Re: Supplement IV in Response to Data Requests and Workshop Queries in Support of the Application for Certification for the Walnut Creek Energy Park (05-AFC-02)

Contents	1
Introduction	3
Transmission System Engineering	5
WSQ8 Generation Tie-Line Route.....	5
Visible Plume Modeling	11
DR77 Visible Plume Modeling Results.....	13
Visual Resources	17
DR91 Landscape and Irrigation Plan.....	19

WALNUT CREEK ENERGY PARK
CITY OF INDUSTRY, CALIFORNIA

Walnut Creek Cooling Tower
Plume Modeling Analyses
PLUME LENGTH
% Hours/Annual (Good Visible Hrs)
Using Ontario, CA Met data
RED = 20% or more

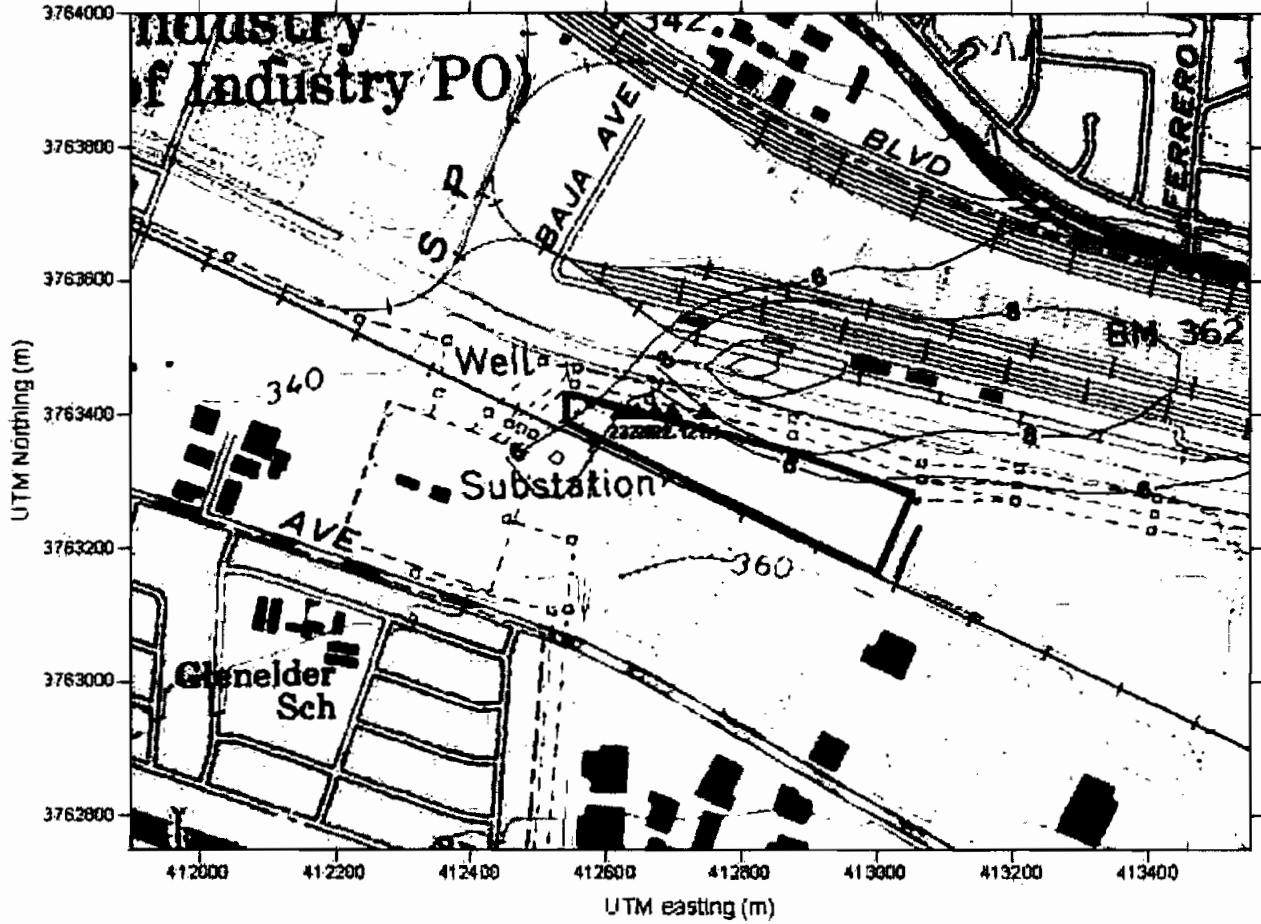
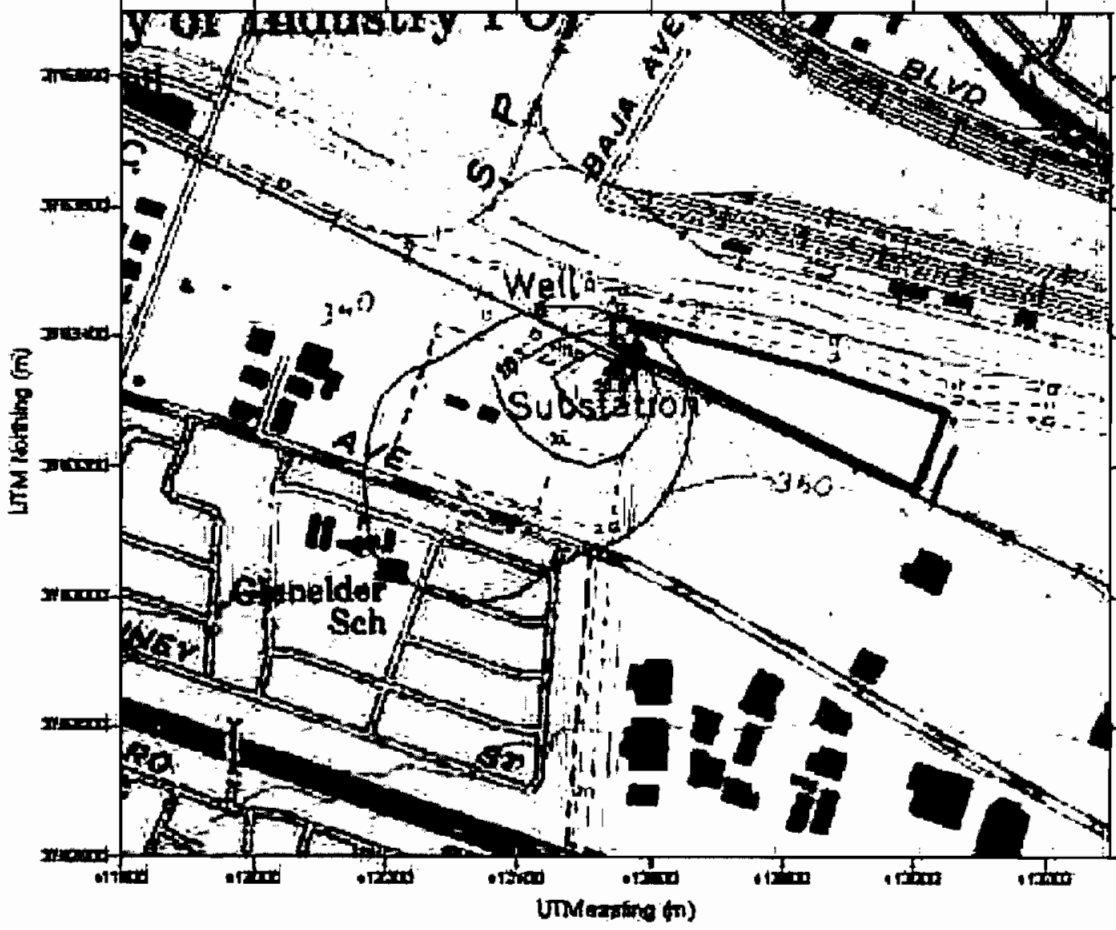
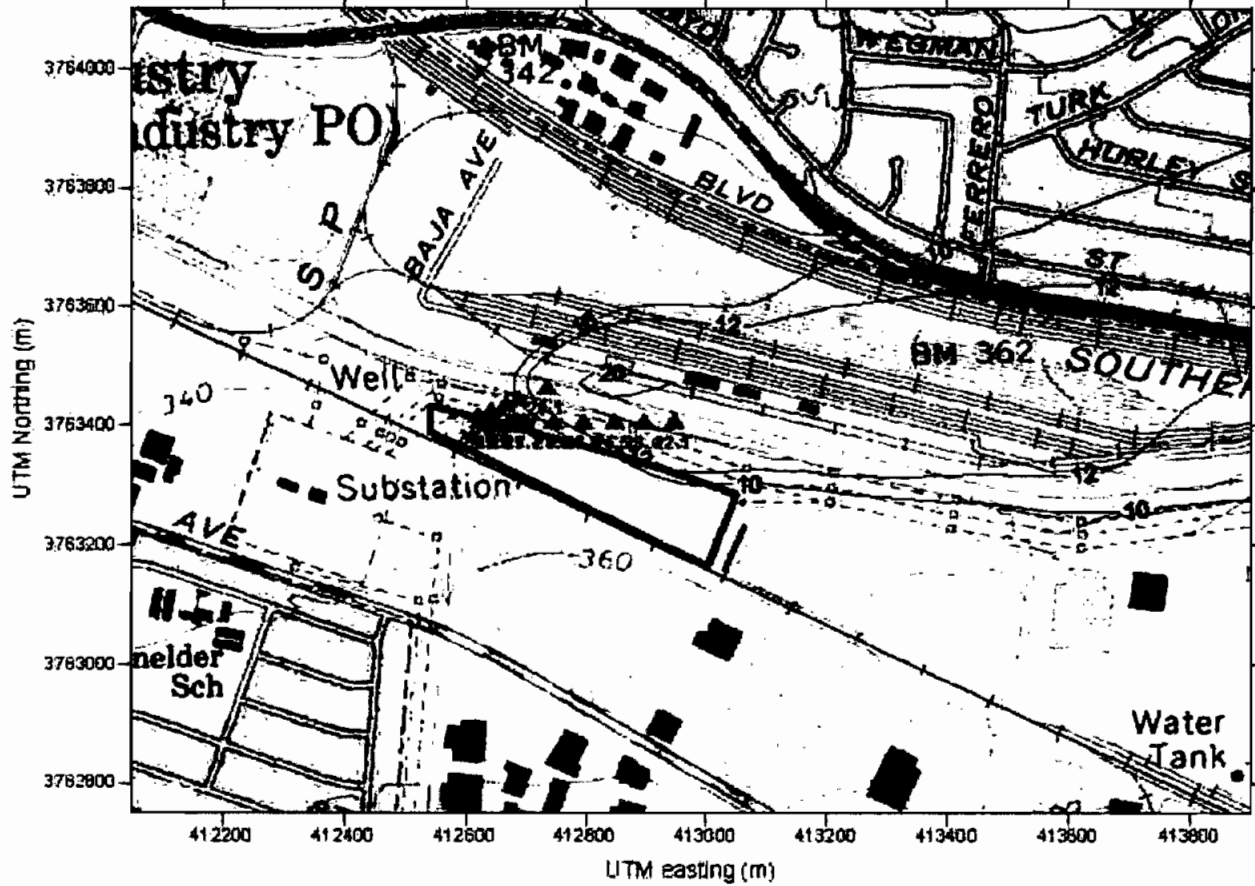
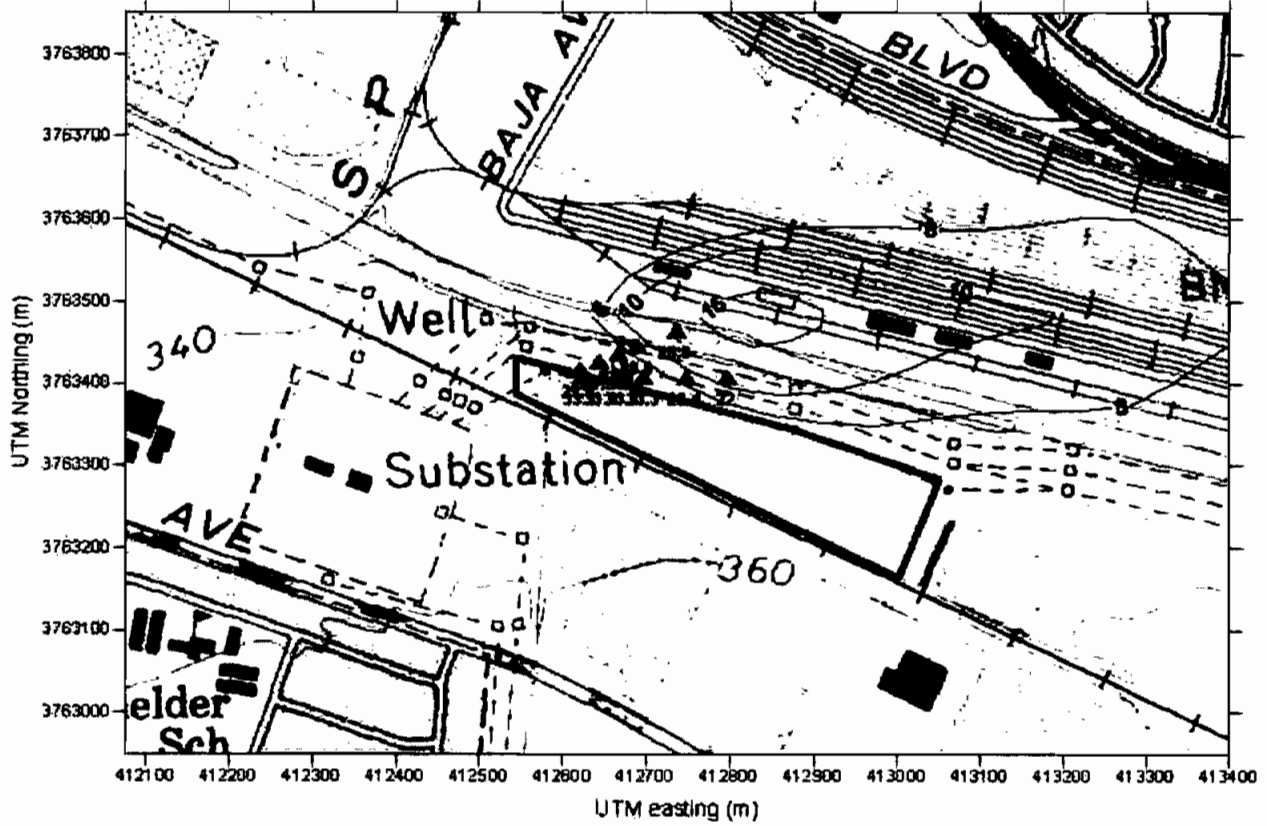
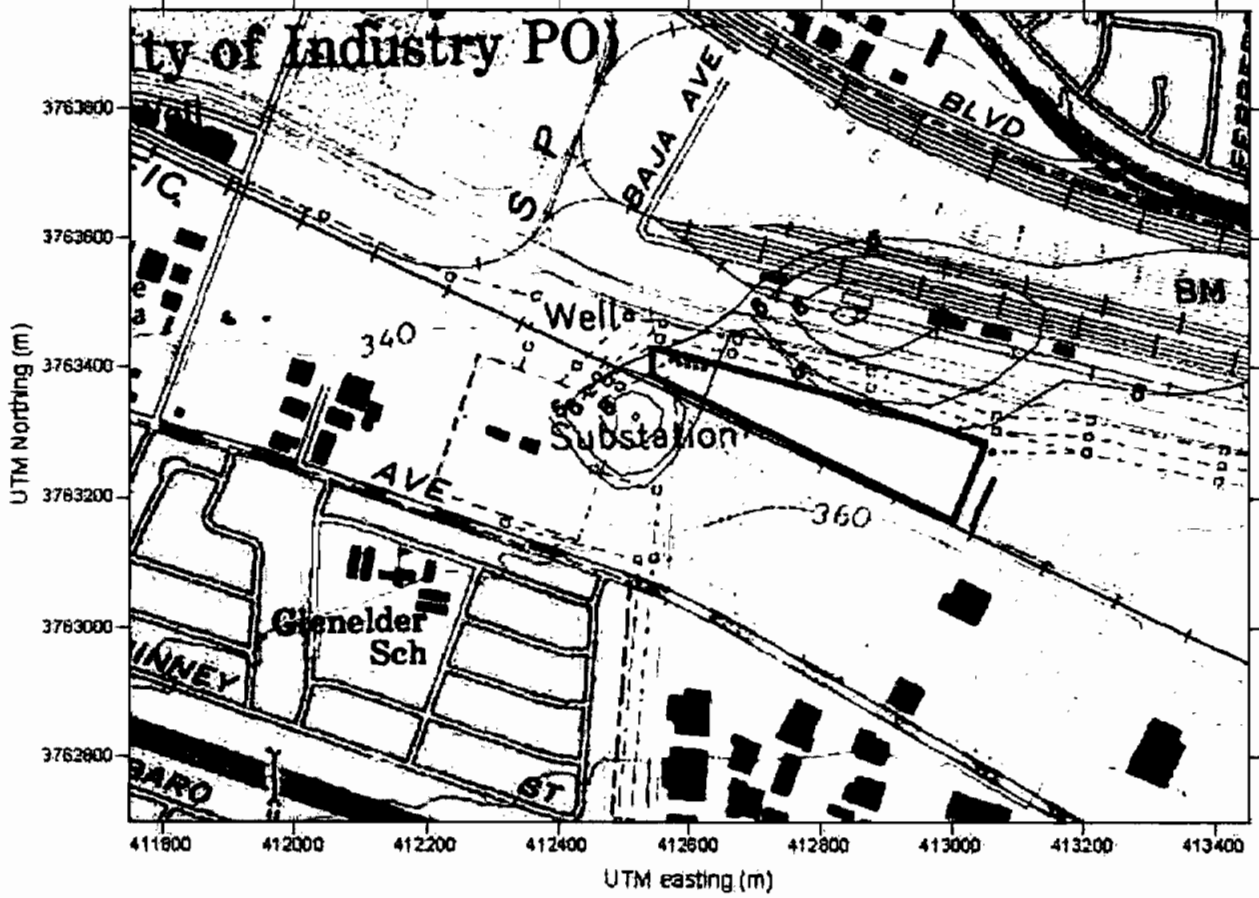
DR77. *If the applicant performed a visible plume modeling analysis in support of the AFC Visual Resources conclusion, please provide:*

- a. the modeling results;*
- b. any meteorological data used in the analysis;*
- c. a full discussion of all assumptions;*
- d. the name and version of the model used; and*
- e. all model input and output files.*

The results of the cooling tower analysis are summarized in Attachments 1-5 for the tower for the annual and seasonal seasons. The attachments present the frequency distributions of one of the primary model output variables, namely plume length and height, which are depicted by downwind sector and radial distance from the center of the cooling tower array.

The SACTI results are summarized below on an annual basis, and for each of the four seasons. The annual summary values indicate that the majority of visible plumes will be less than 300 meters (984 feet) in length. Modeling results indicate that, based on total hours, plume formation will occur 20 percent of the time during valid visible hours at locations up to 2000 meters from the site. Larger downwind visible plume lengths are possible and are predicted during the spring and winter seasons, but the downwind visible plume length will be less than 400 meters (1300 feet) for 62 percent of all the hours where a visible plume will form. SACTI also predicts that the visible plume height will average 175 meters, and have a median radius of 40 meters (131 feet) on an annual basis. For the winter season, the average plume length (when visible) will be longer, at 325 meters (1066 feet). For winter, SACTI predicts an average visible plume height of 175 meters with a median radius of 45 meters, similar to the annual averages.
